25 BEDFORD SQUARE – 2015/4185/P & 2015/4855/L

Delegated Report		Analysis sheet	Expiry Date:	17/09/2015
(Members Briefing)		N/A	Consultation Expiry Date:	
Officer		Application Number(s)		
Matthias Gentet		2015/4185/P & 2015/4855/L		
Application Address		Drawing Numbers		
25 Bedford Square London WC1B 3HH		Combined VRV Schedules; Noise Impact Assessment; Heritage Statement; Cover Letter (dated 21/07/2015); Design and Access Statement; Agent's Response to CAAC comments (dated 01/10/2015); D-301; E-400; [GA-] 100; 101; 102; 103; 104; 105; [25-] D00; D01; D02; D03; D04; D05; D06; DT000 RevA; DT07 RevA; E01; E02; E03; E04; E05; E06; E07 RevA; E00; E000; LP1; P01; P02; P03; P04 RevA; P05; P06 RevA; P07 RevA; P00; P000; P000 RevA; [TPS/25BS/] B/EX/M RevA; B/M RevC; G/EX/M RevA; G/M RevA; 1/EX/M RevA; 1/M RevA; 2/EX/M RevA; 2/M RevA; 3/EX/M RevA; 3/M RevA; R/EX/M RevA; R/M RevA; EL/EX/F RevA; EL/F RevA; EL/EX/R RevA; EL/R RevB; VRV/J; VRV/M; [25BS-] TN1; TN2.

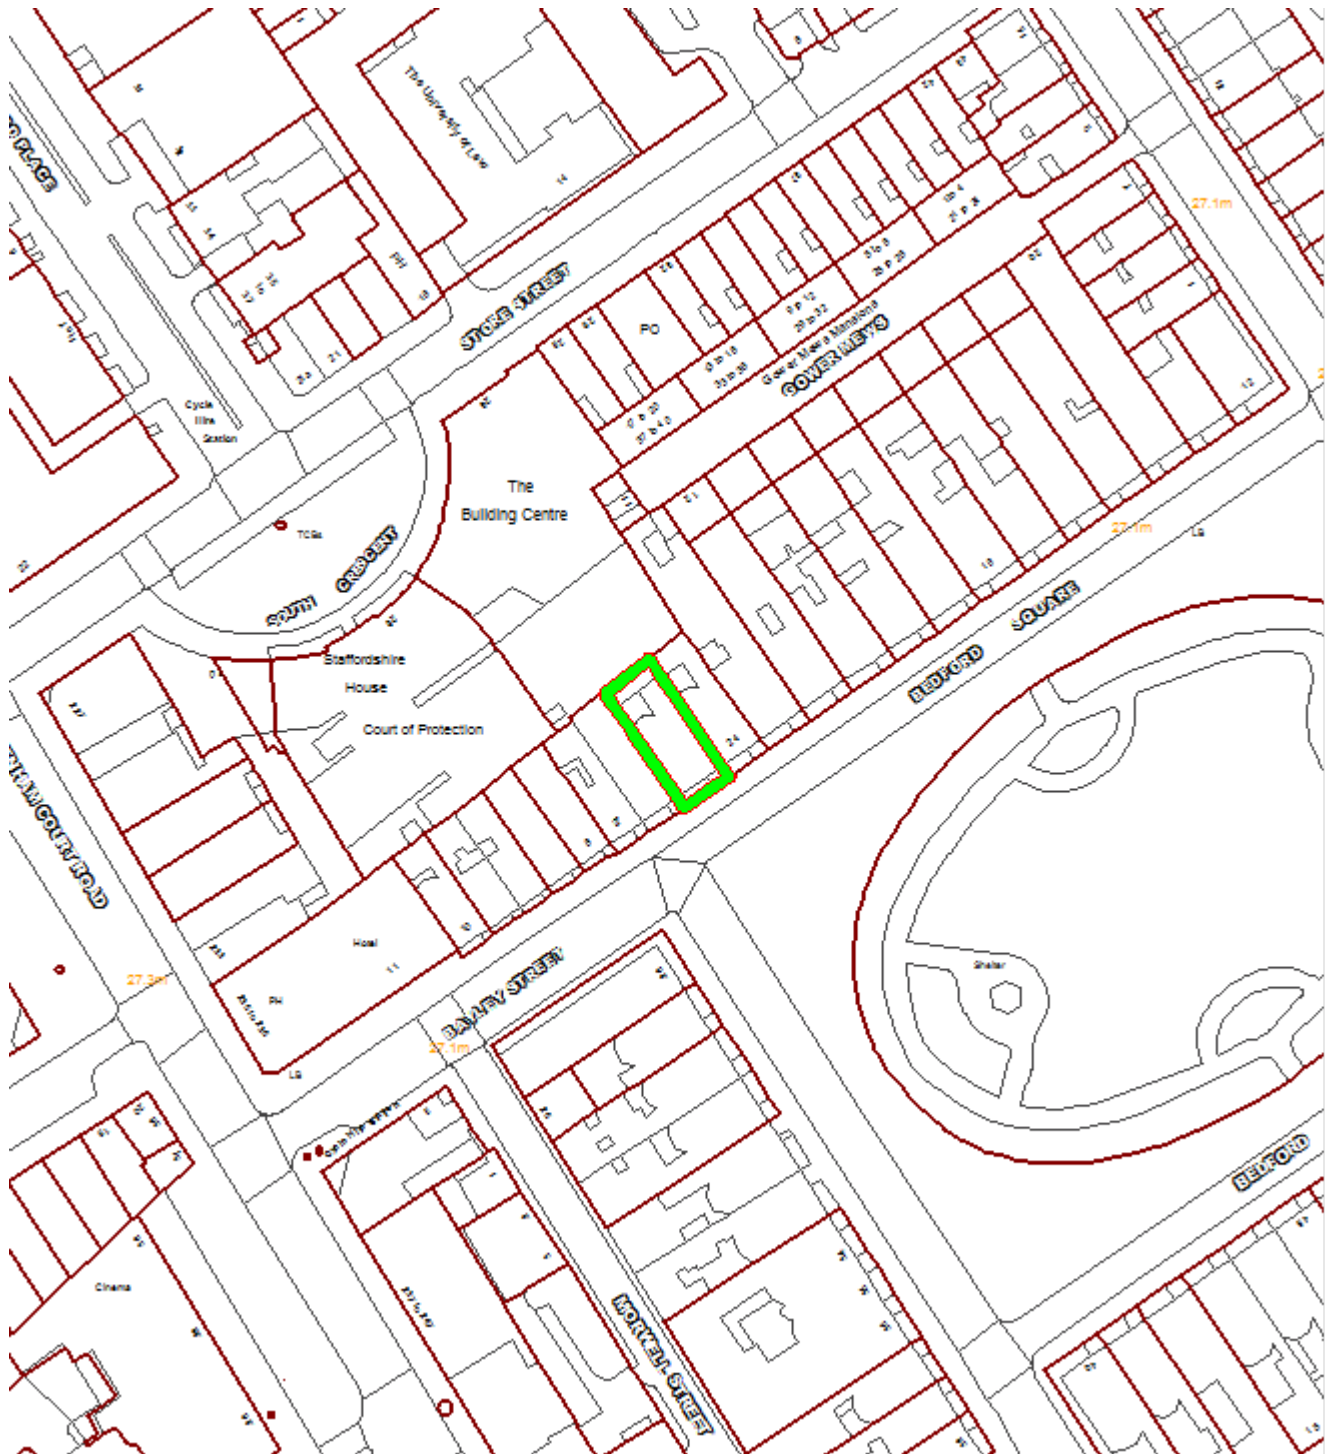
Rear area – Extension

Roof Area – A/C units

Front Area – Steps and walkway
